Today's Outline

Summary of Community Response

Preferred Option from October 2022 Meeting

Pond Dewatering During Construction

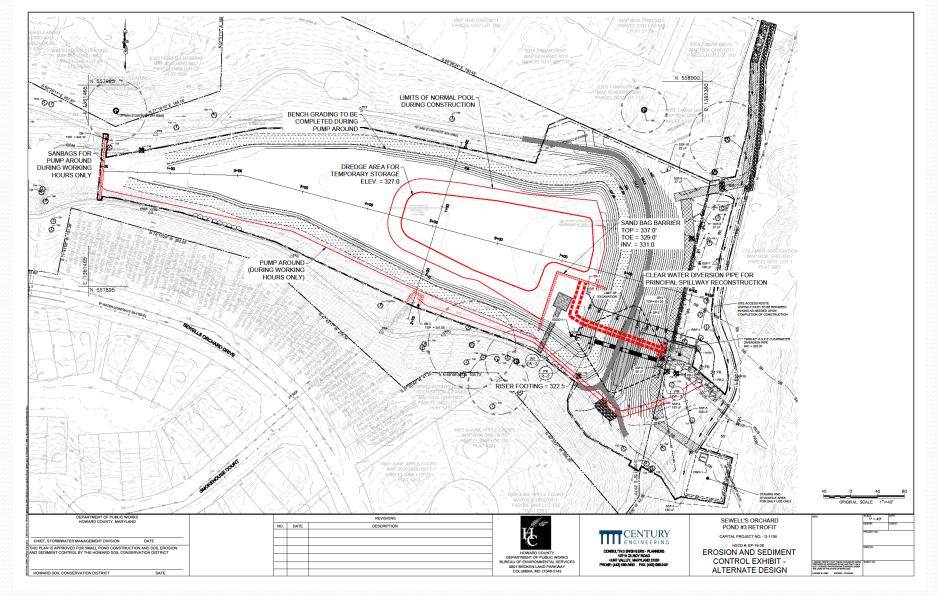
- Dewatering/draining ponds should be minimized
- Relocate fish as humanely as possible

- Additional team discussions. Concept shown at October public meeting is the best practical option.
- County has confirmed with MD DNR that we can move fish and other aquatic wildlife as practical to next upstream pond during dewatering.
